Product News Bulletin | #PN6490001020 | *Revised & reissued August 11, 2009

Applicable to Eaton's Carter brand Model 60600, 60700, 61525, 64800, & 64900 hydrant couplers and Model 44665 & 47245 coupler lower half assemblies

API/EI Bulletin 1584 2nd and 3rd Edition Couplers Now Available

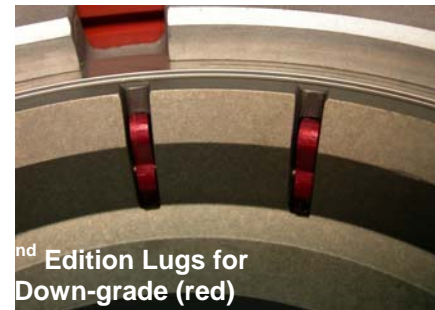
These hydrant coupler lower halves will be manufactured with **RED** locking lugs (part number 200688) and will also be **RED** tagged to notify the end-user that the couplers only meet the requirements of API/EI Bulletin 1584, 2nd edition.
